TG13.1 – Roof Park Landscaping and Irrigation

Questions are numbered in the order received. Numbers missing in the sequence either have been answered in a previous response set or will be answered in a future set.

1 PARK LEVEL PLANT LAYOUT AT STAIR 301
SCALE: 1/4" = 1'-0"

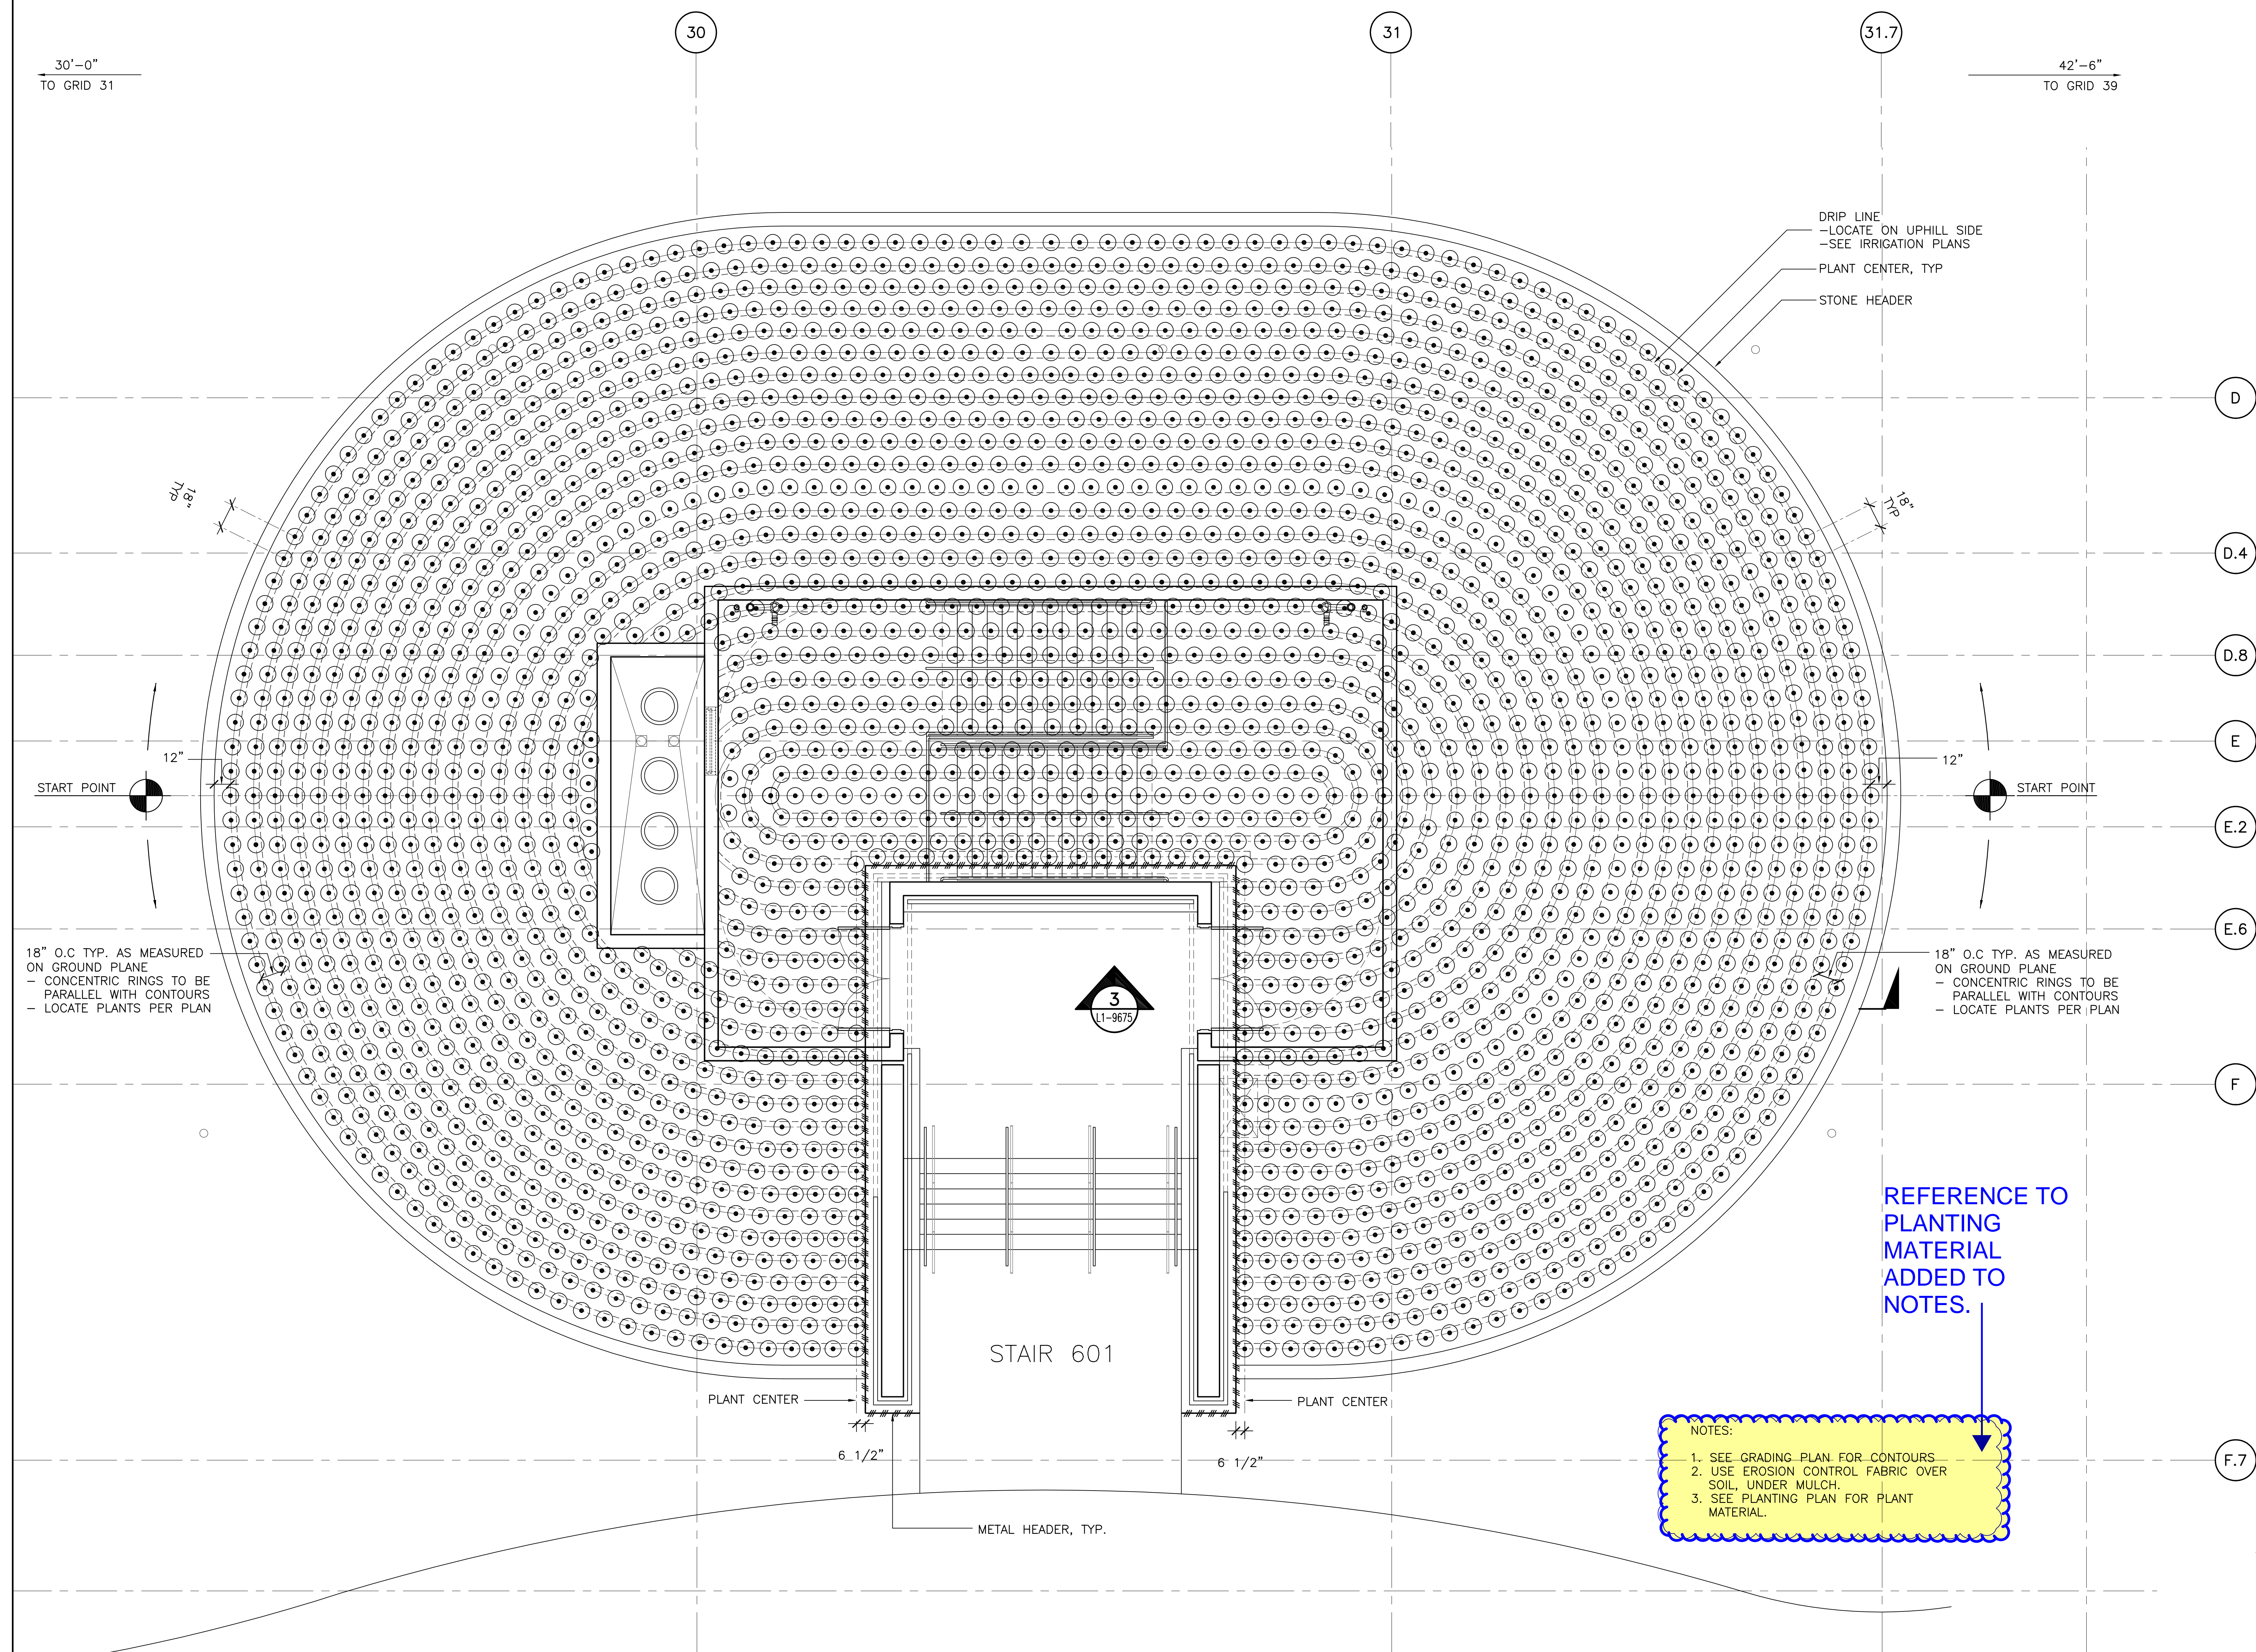
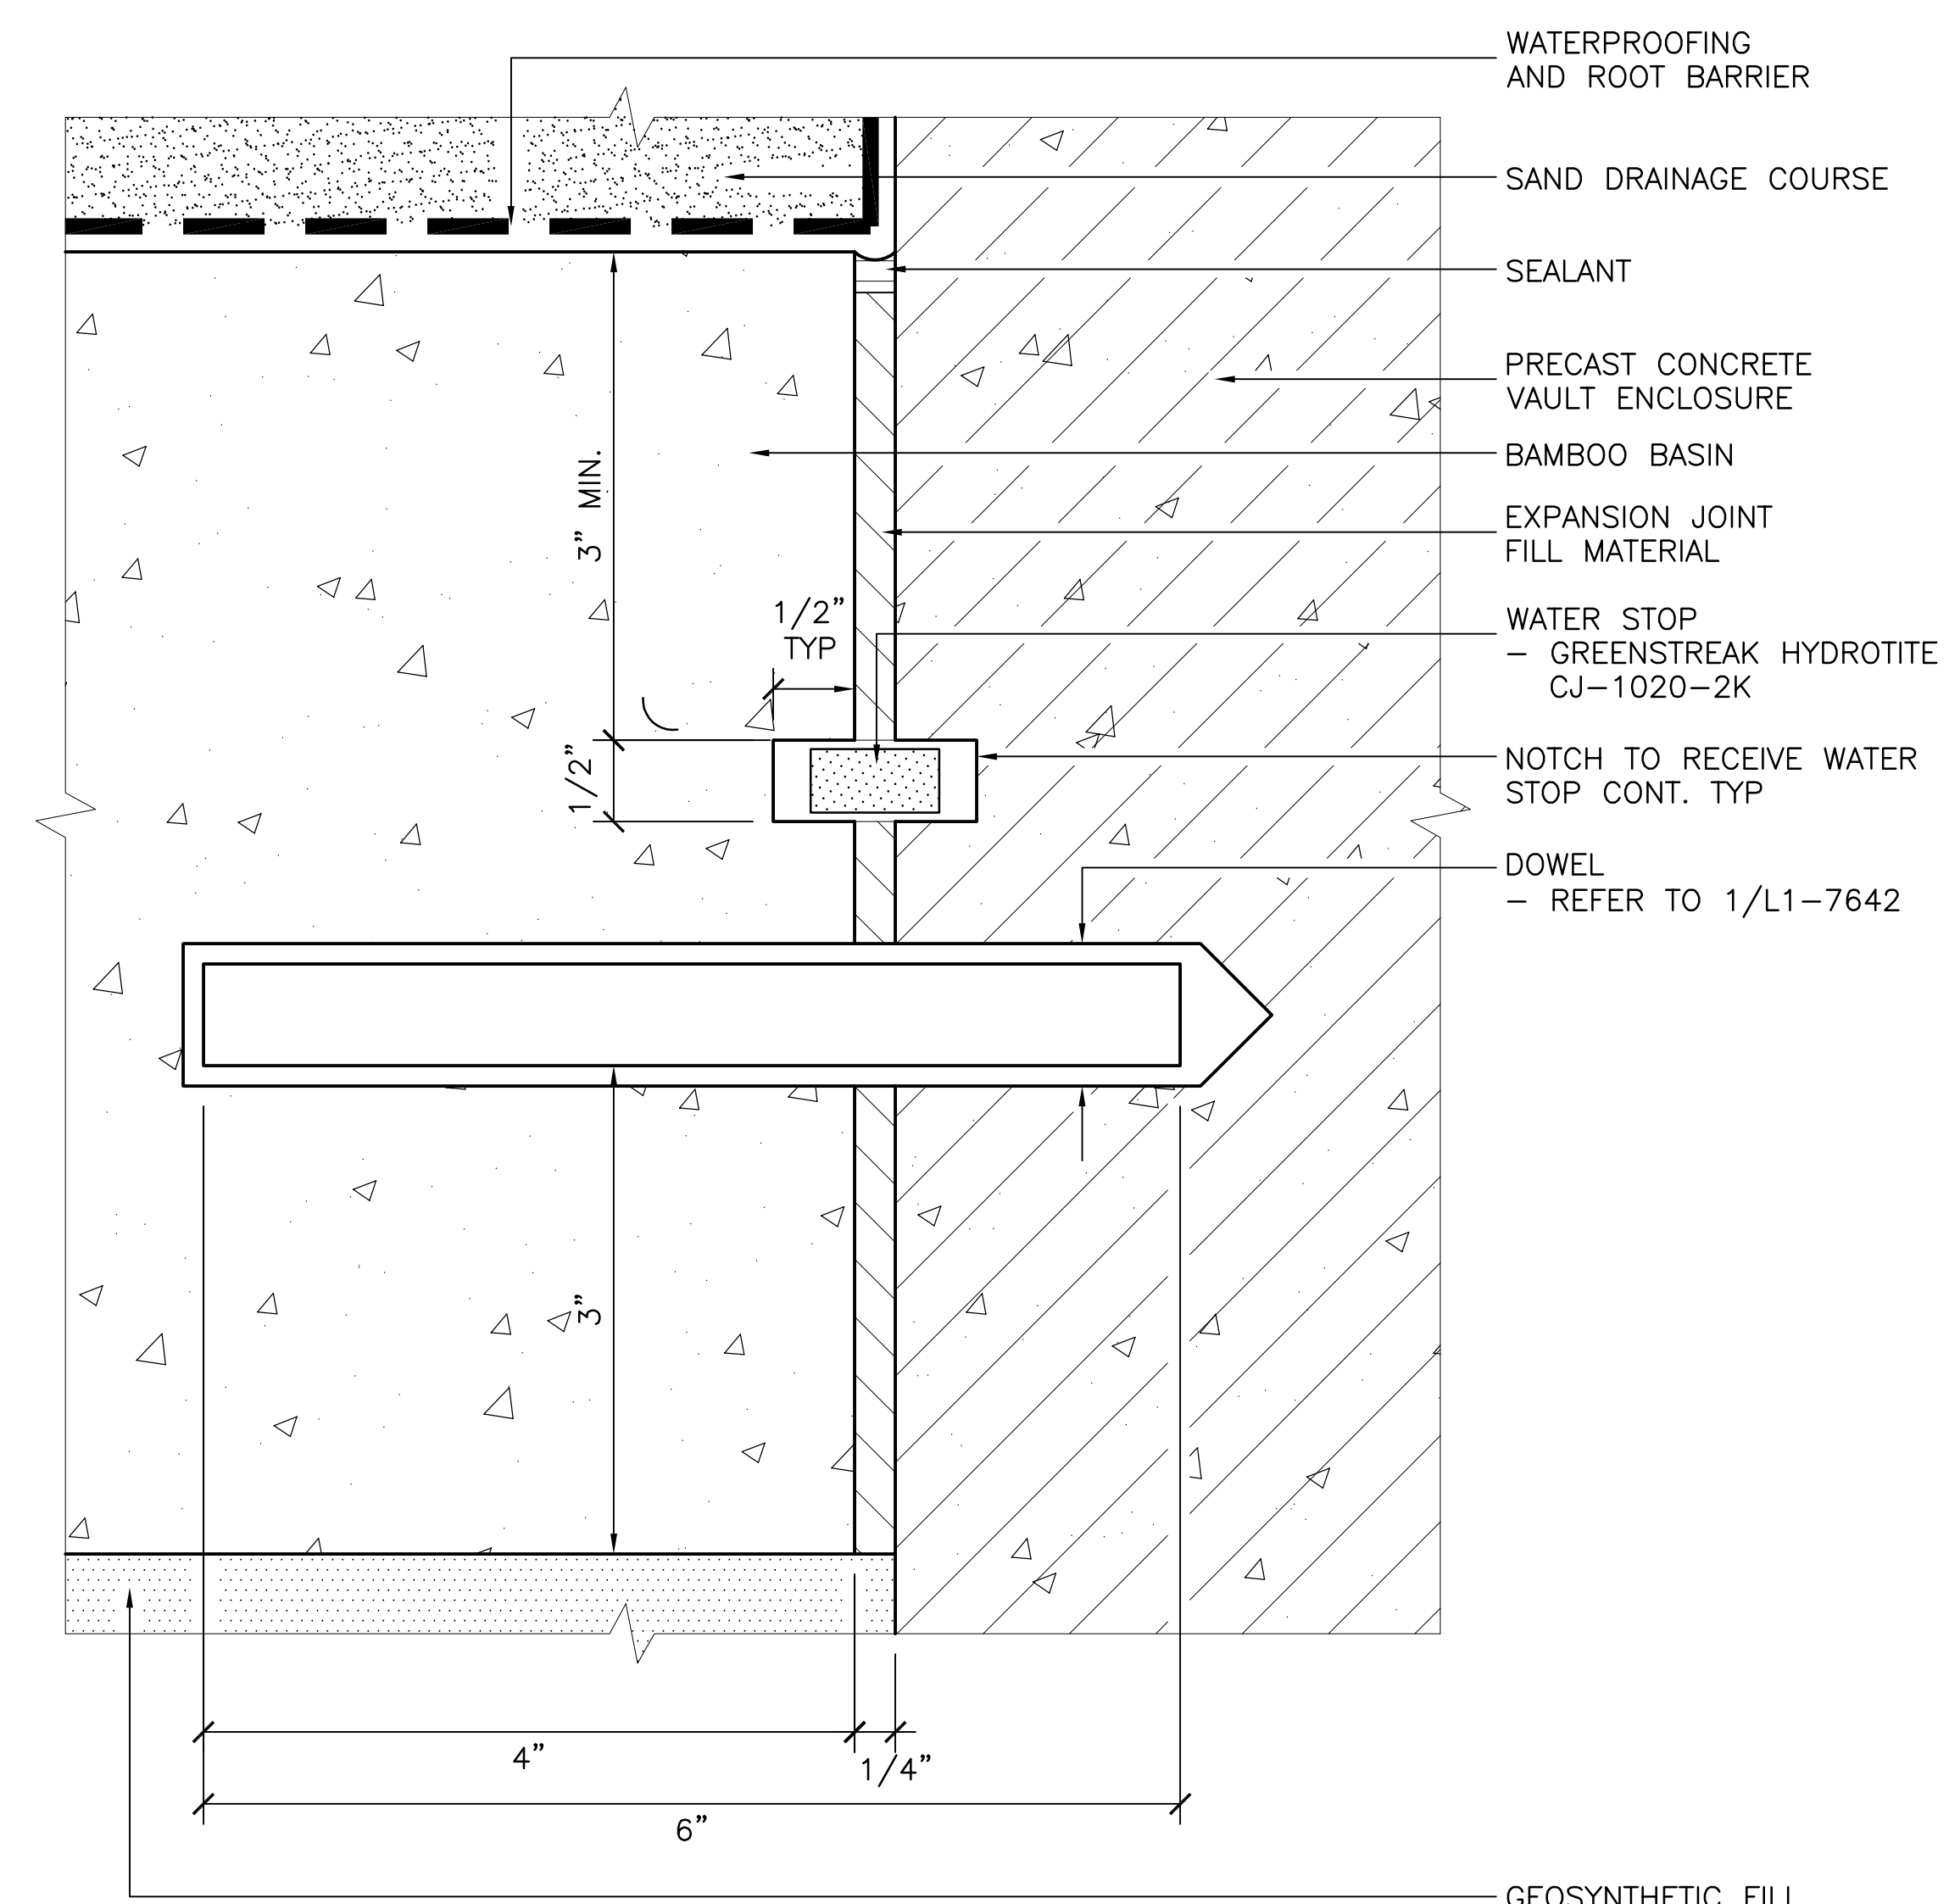
TG13.1-023	3/25/2015	L1-6623, L1-6626, L1-9680, L1-9681		Define the type of plant required on the East and West Mounds. L1-9680 shows ta on the detail, but there is no ta in the Shrubs and Perennials Schedule. L1-9681 only shows black dots.	The planting required on the east and west mounds is Trachelospermum Asiaticum, identified as "GC-TA" on sheets L1-6623 and L1-6626, and identified on the planting legend sheet L-0009. Please refer to SKLA 385.1, 385.2, 385.3 and 385.4.
TG13.1-024	3/25/2015	L1-1605, L1-1606		Provide details for Utility Vaults within the Bamboo Grove Basins.	Please refer to attached SKLA 387 for the utility vault within the bamboo basins.
TG13.1-025	3/25/2015	L1-4606		The Stair 601 area drain in paving at GL 30.3 / F shows an invert elevation of 84.09 which is higher than the drain lines flowing to it. Confirm if this is in fact the correct elevation. If this is incorrect, provide the correct elevation and update the detail.	The invert elevation at the stair 601 area drain was omitted as shown on attached SKLA 384-1. Please refer to architectural and plumbing details for the drainage.
